Product /Process Change Notification

PCN number: PCN-20180087

Description of Change:

Lite-On would like to change packaging for all SMD Chip LED. Dimensions of inner box and outer carton, color of the reel, and taping quantity per reel will be changed. The affected specification are listed as below.

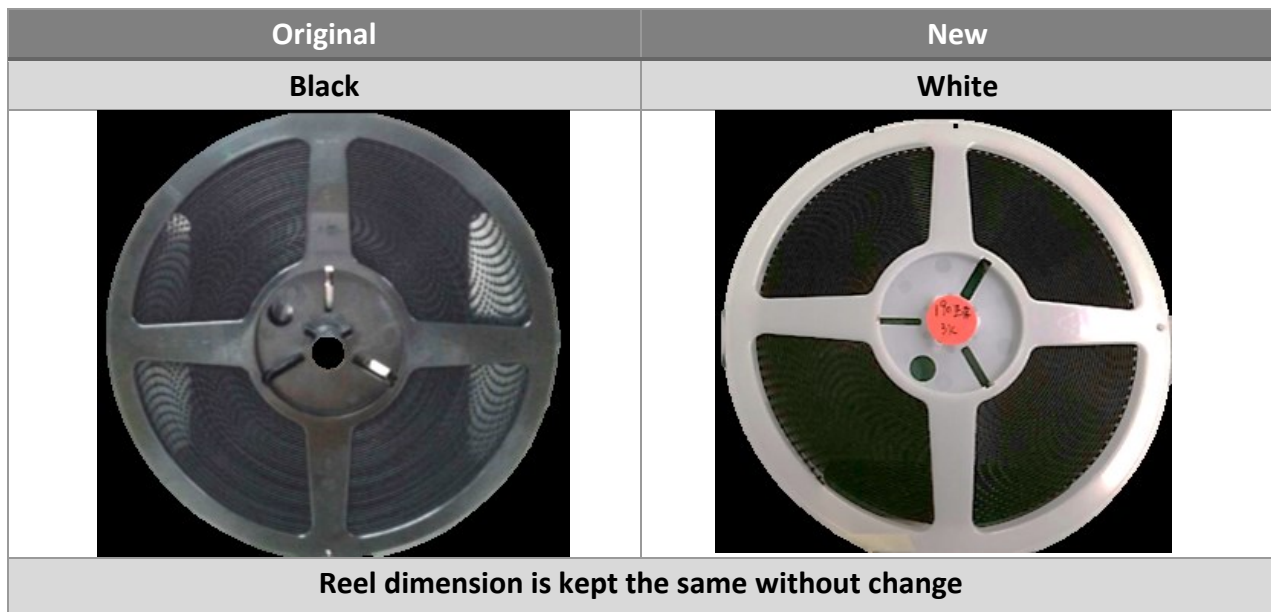
1. Color of Reel:

Unify all reels to be white color.
